Evidence Book 13

Township of Guelph/Eramosa Noise Impact Review Document Book

Noise Impact Review Document Book Index

**Re: Peer Review, Acoustical Study
Hidden Quarry
Novus Project No. 12-0258**

Fig 1.6

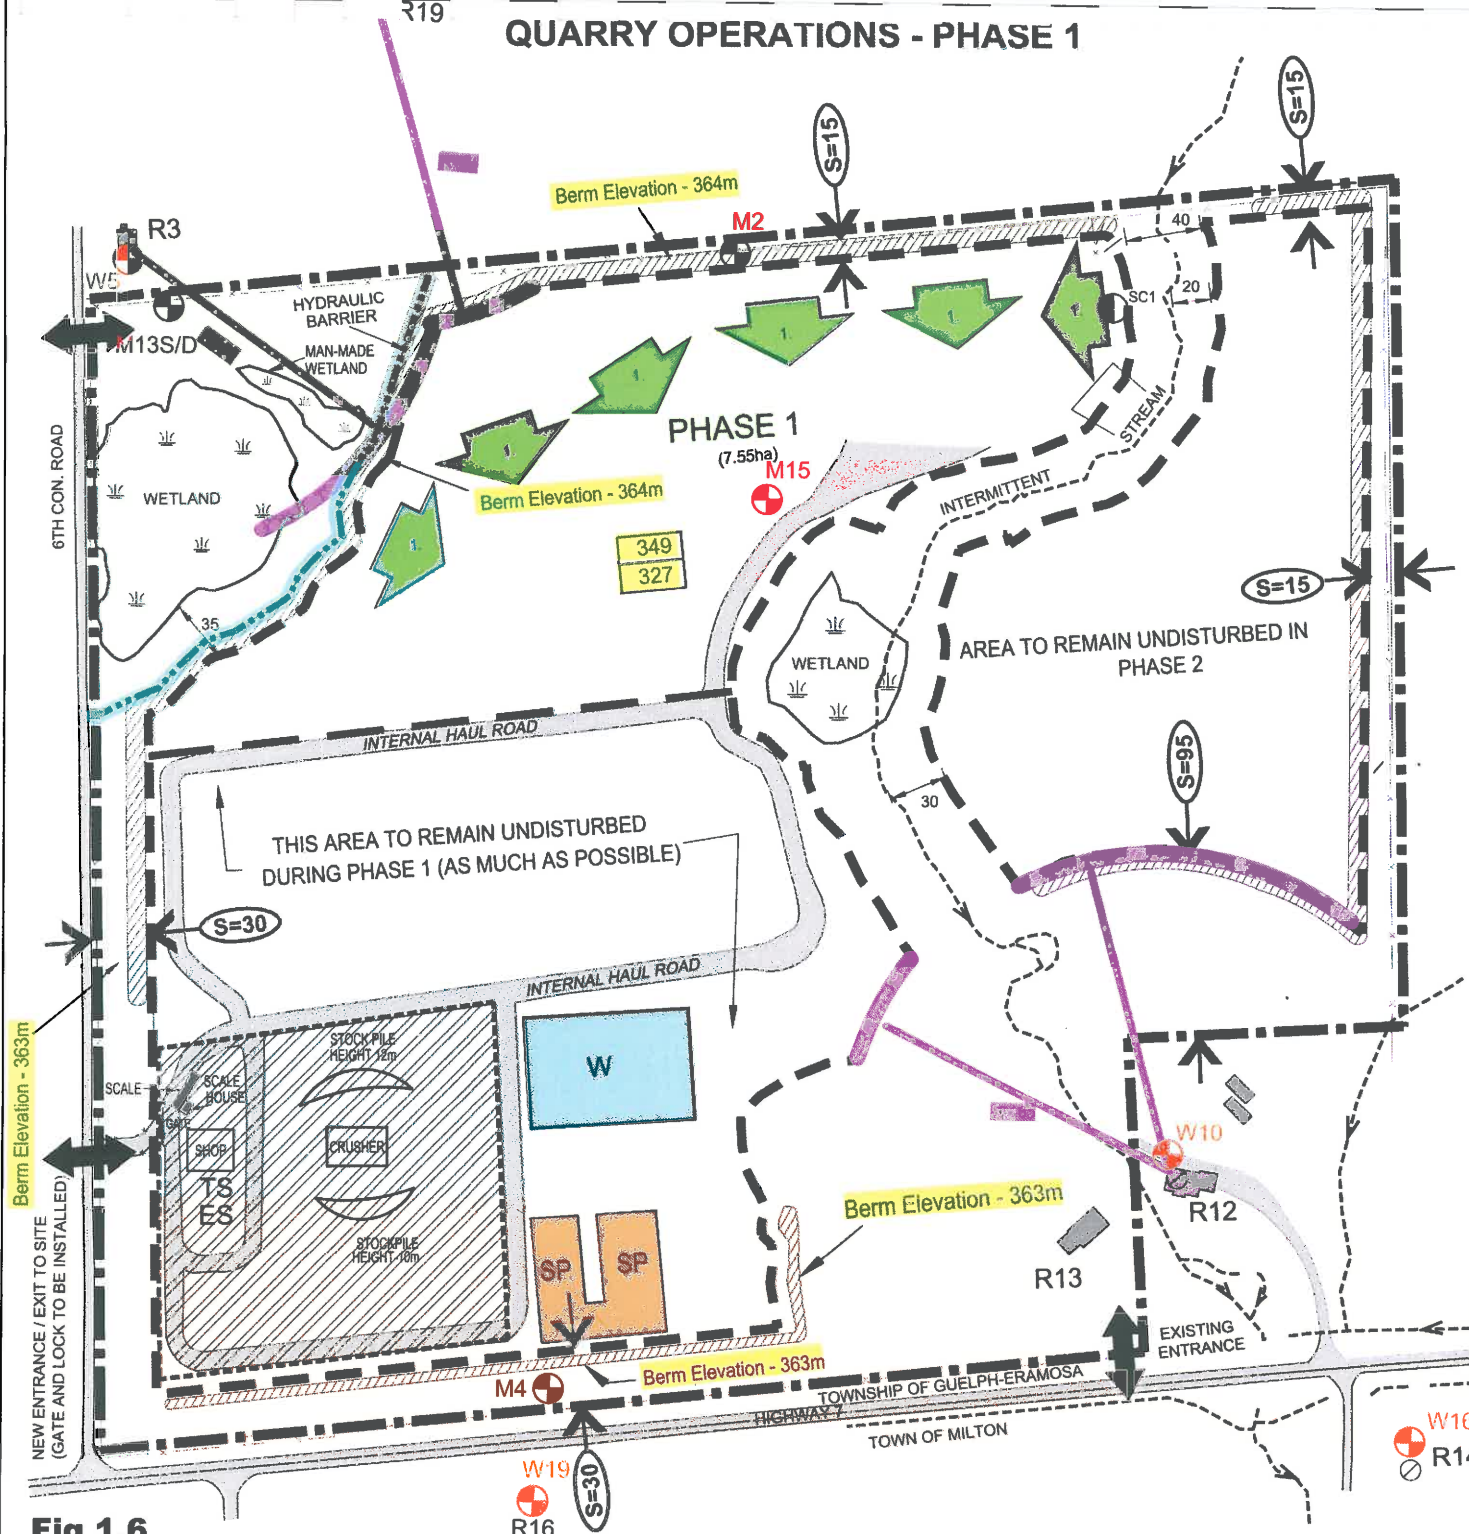
- The Applicant has elected to initiate Phase 1 dolostone subaqueous extraction in the upgradient high water table area on the north side the quarry (Fig 2.2). The Site Plans specify the operational staging pit floor at the approximate top of bedrock at 349 m asl elevation (Fig 1.6).

- The Site Plan notes assume that water will be able to percolate from the quarry floor to the underlying water table (s3.2.1.2).
- Based on the Applicant bedrock water level monitoring, the only areas of the proposed pit floor where infiltration (percolation) can occur in Phase 1 and Phase 3 areas is in a limited area of quarry floor north of M4 (Fig 1.6).

Fig 1.6 The Noise Report recommended establishing the Processing Areas and Internal Haul Roads at 349 m asl (also Fig 1.5). These 349 m asl pit floor elevations are specified in the Phase 1 area but not on the corresponding internal haul road and processing area locations on the Applicant Site Plans.

Fig 1.7

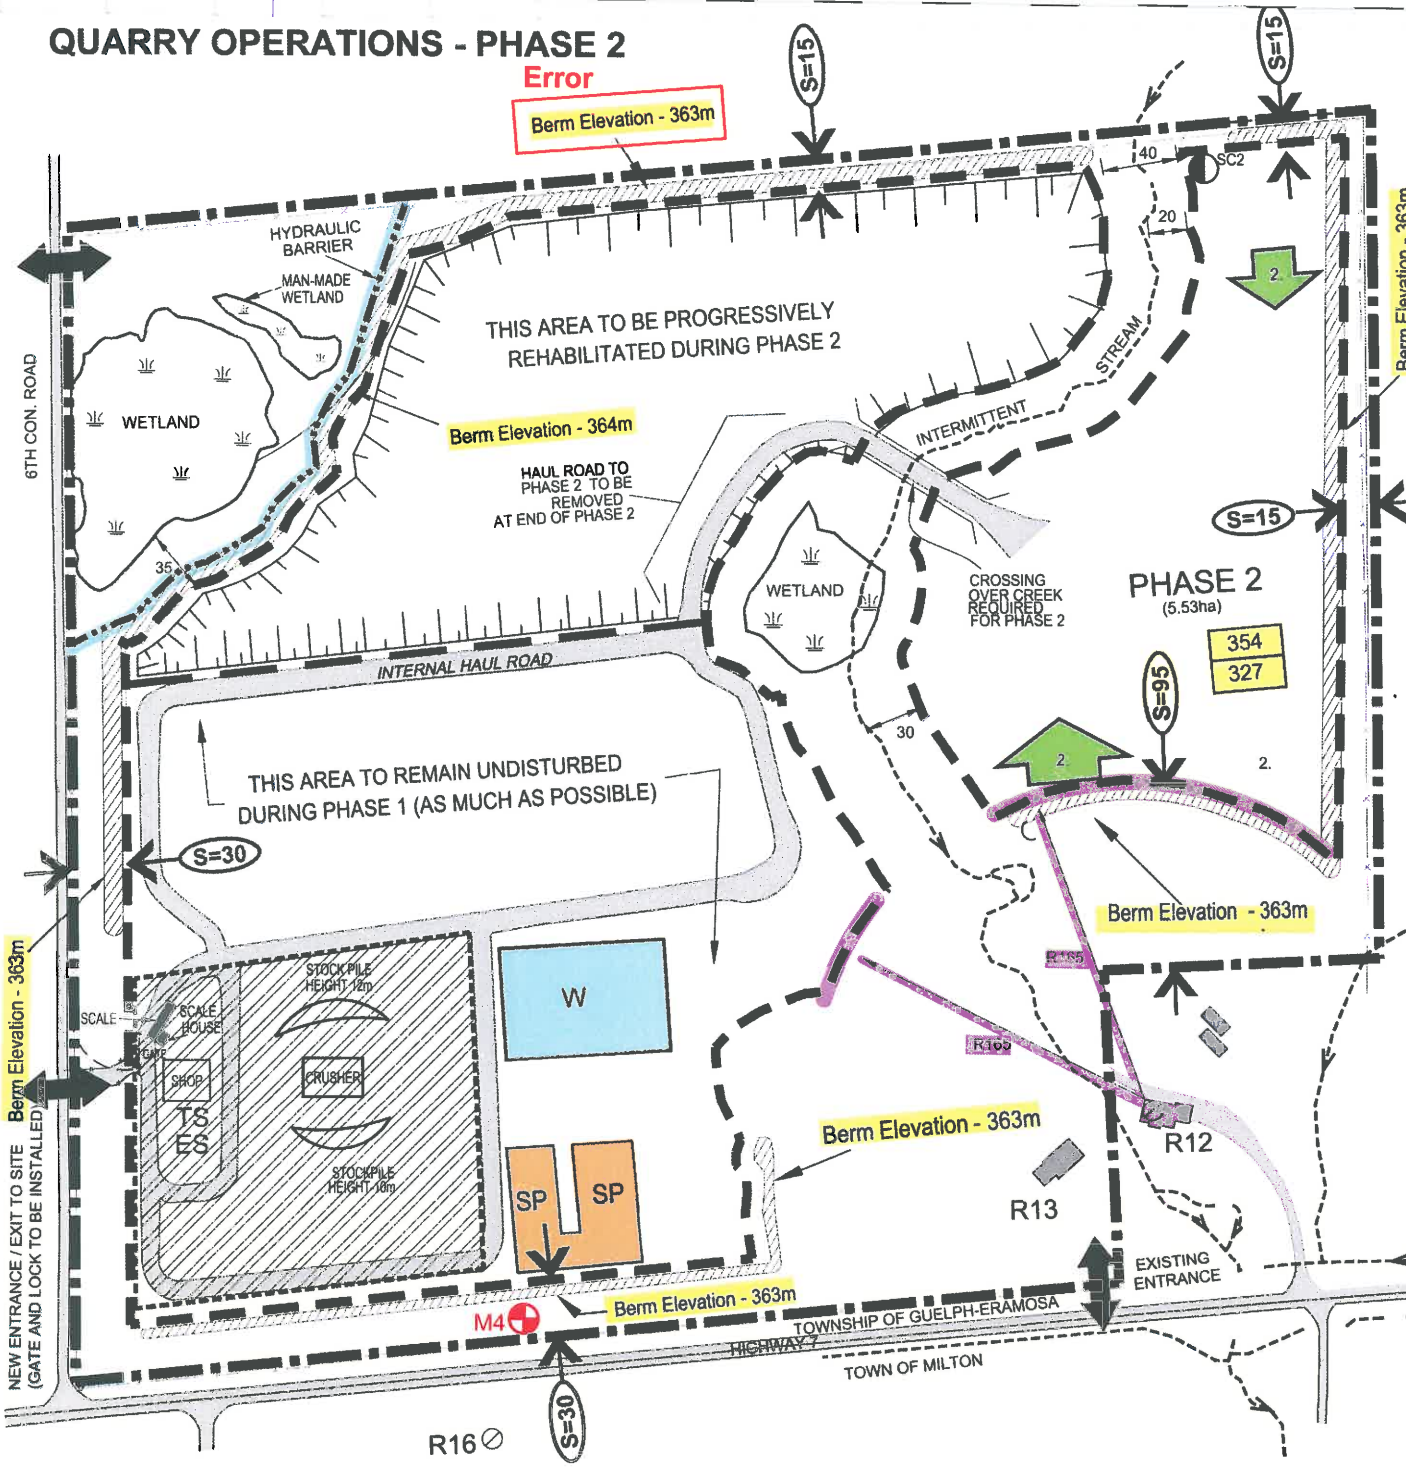
The Blasting Impact Analysis and the Noise Studies show the north berm elevation at 364 m asl whereas the Site Plan Phase 2 (pg 2 of 5) shows this berm at 363 m asl (Fig 1.7). **This may be a drafting error on the Site Plans.**

Fig 2.2

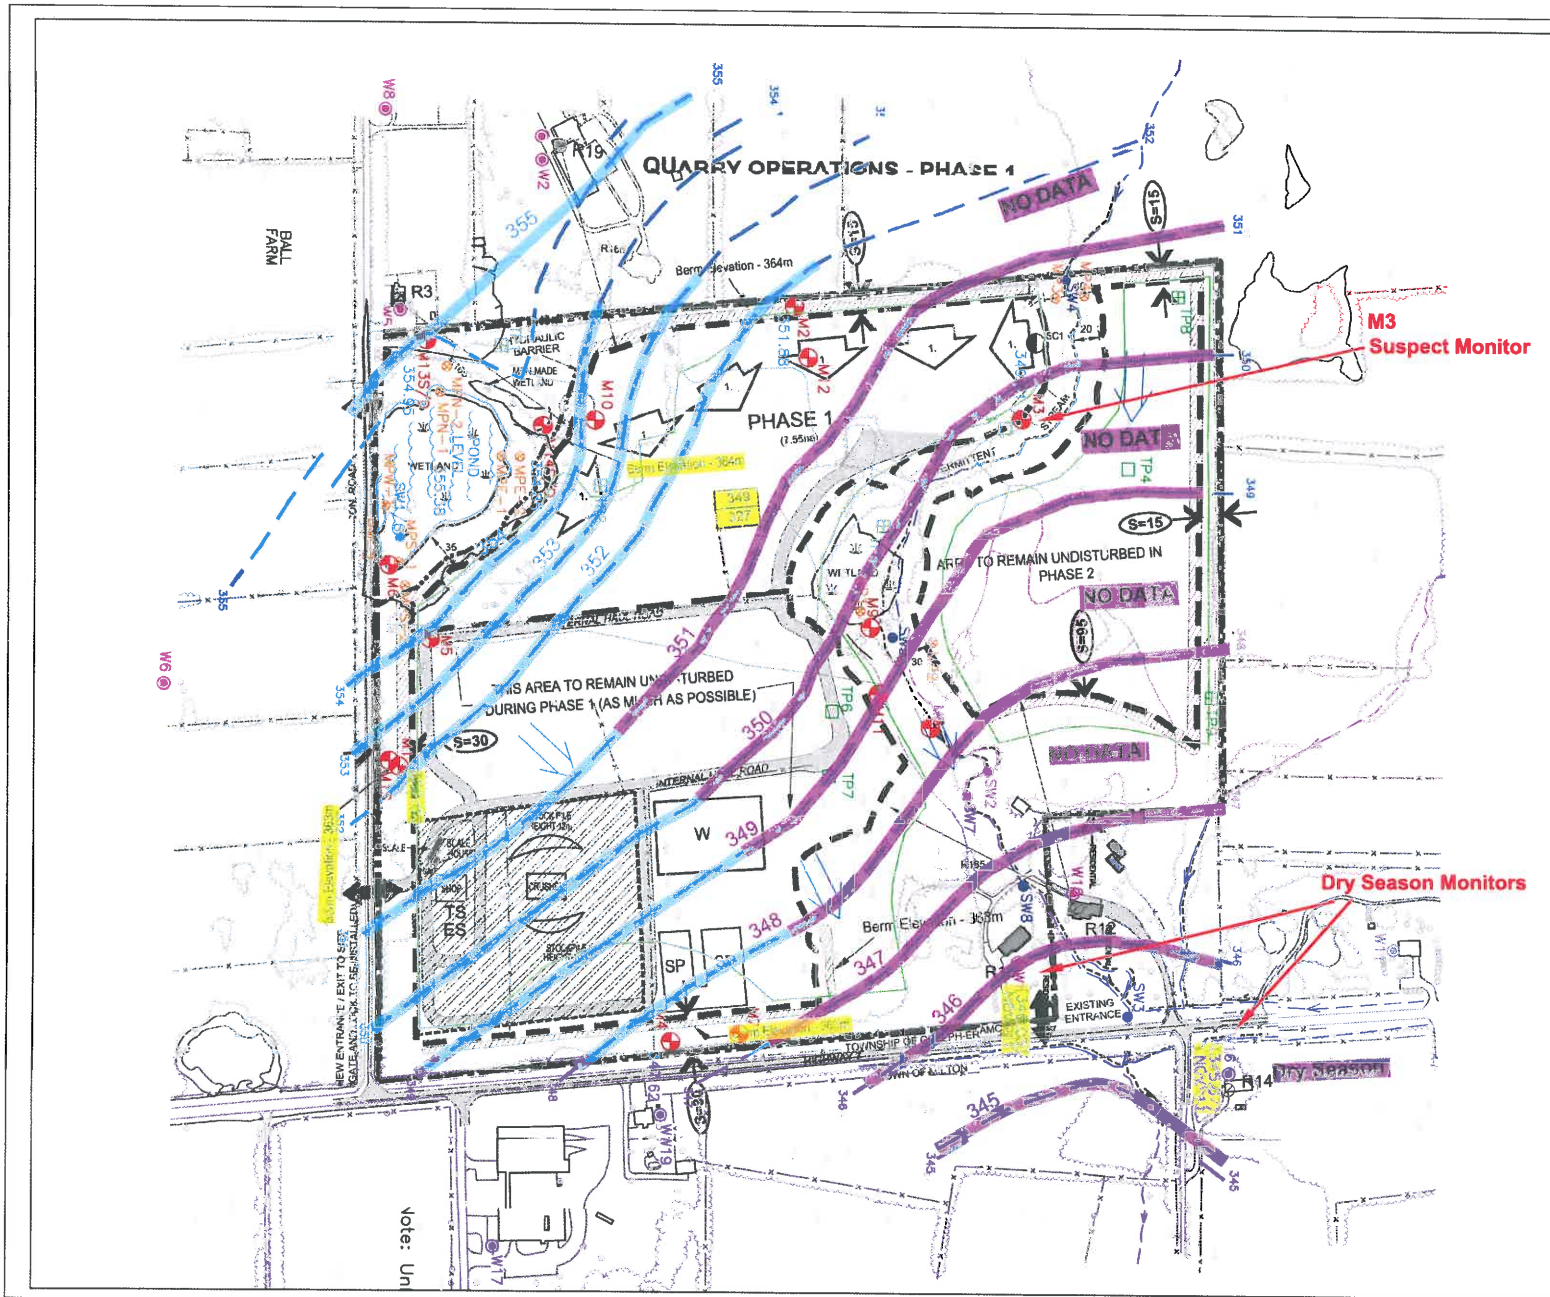
- The Applicant's groundwater model calibration has been influenced by these improvised distorted bedrock water level contours (s2.2.1). **The Applicant has refused to provide us with its calibration data input to its groundwater model for audit.**
- The Applicant's groundwater modelling in the proposed Phase 2 extraction area is unsupported by bedrock groundwater level monitoring (s2.2.2). The modelling calibration is therefore suspect.

Fig 2.3A

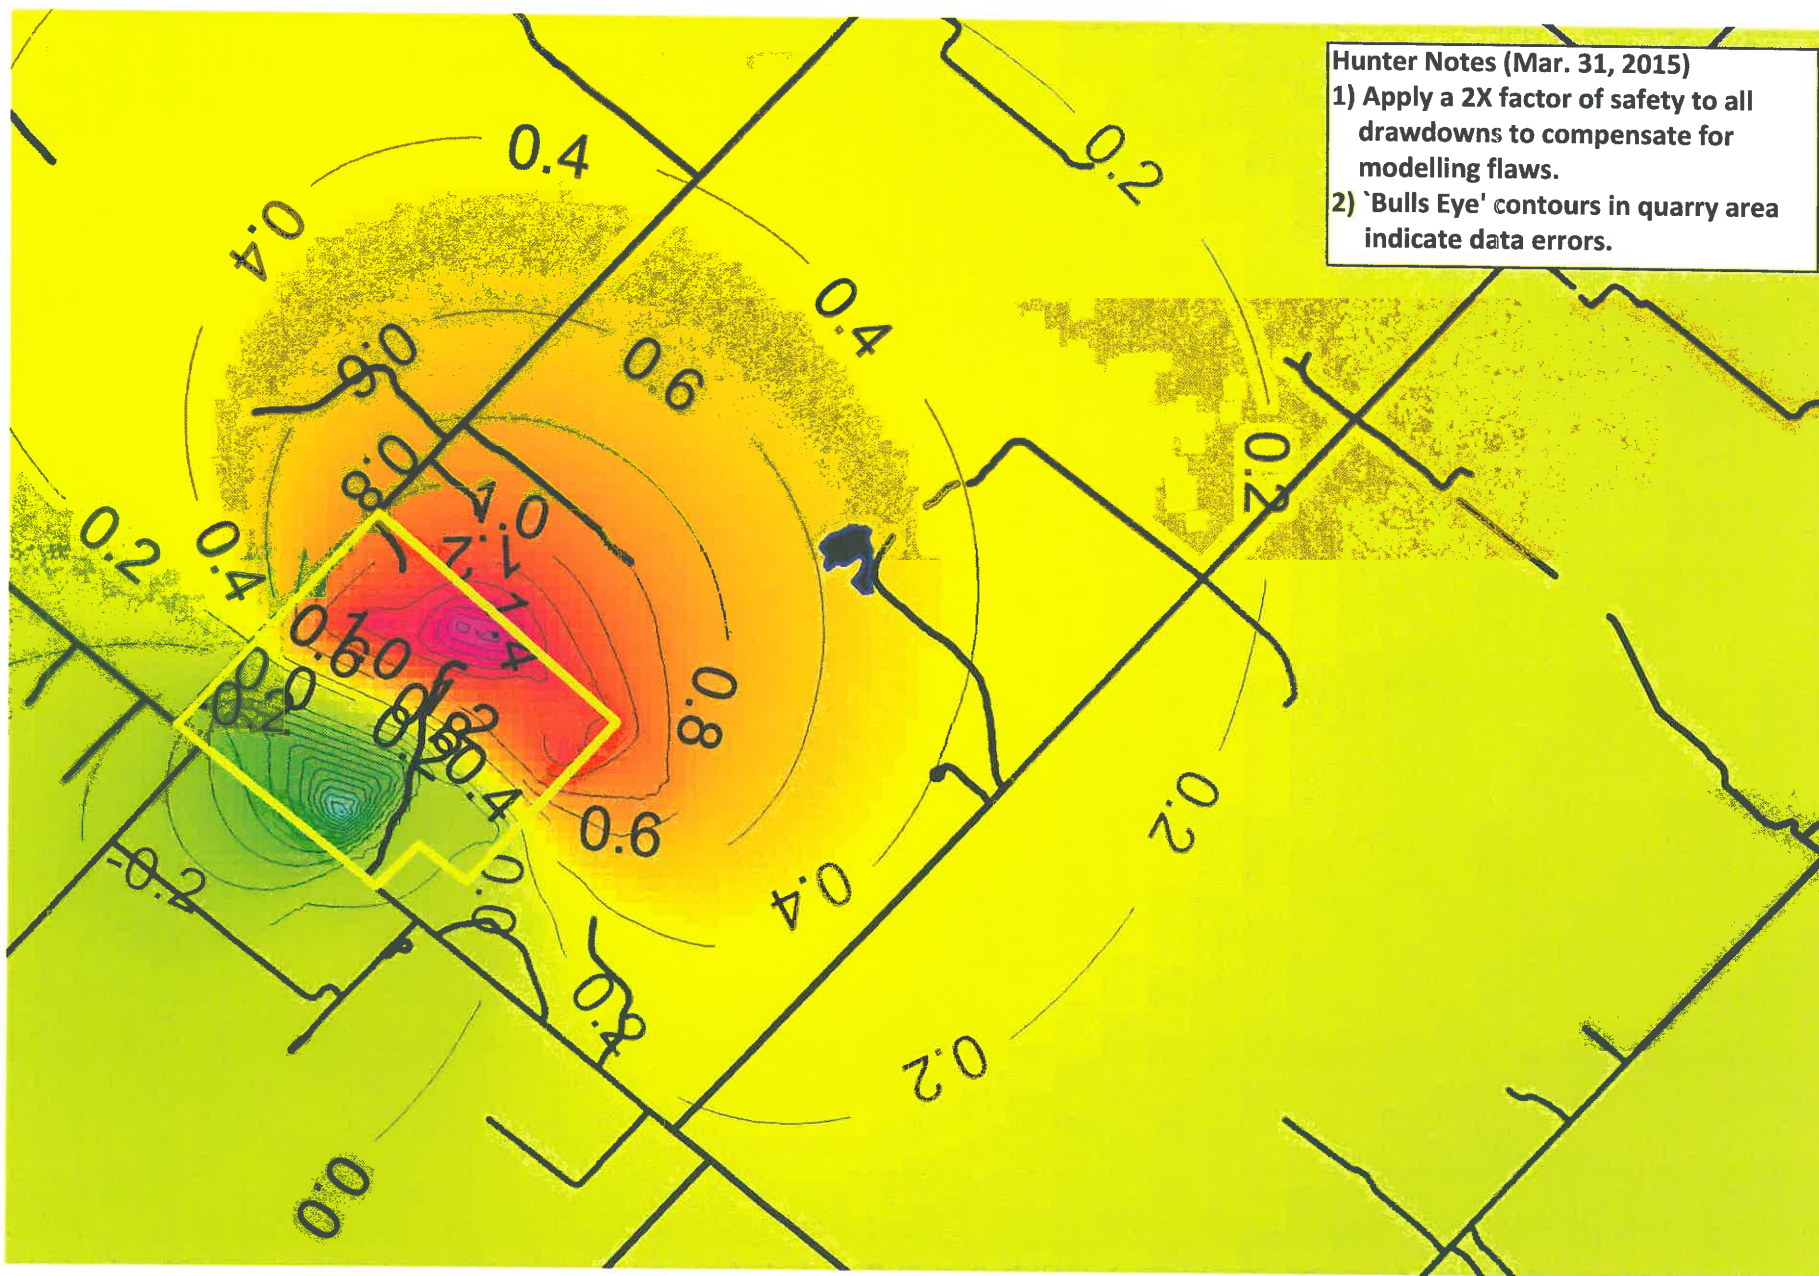
Fig 2.3A Furthermore, the drawdowns shown on Fig 2.3A are post-extraction not operational drawdowns. The Applicant's groundwater model predictions are 'flawed' by its inferred model calibration data (Fig 2.2). For purposes of this Peer Review, I have applied a factor of safety of 2x to the Applicants predicted drawdowns north of the proposed quarry, therefore a 0.6 m drawdown is assumed at 1.2 m for impact assessment purposes. The contour 'bulls-eyes' or 'pimples' in the proposed quarry area indicate data anomalies or errors. The Applicant has refused to provide Hunter with its modelling groundwater level datasets for audit. The Model needs to be recalibrated and rerun prior to Site Plan approval.
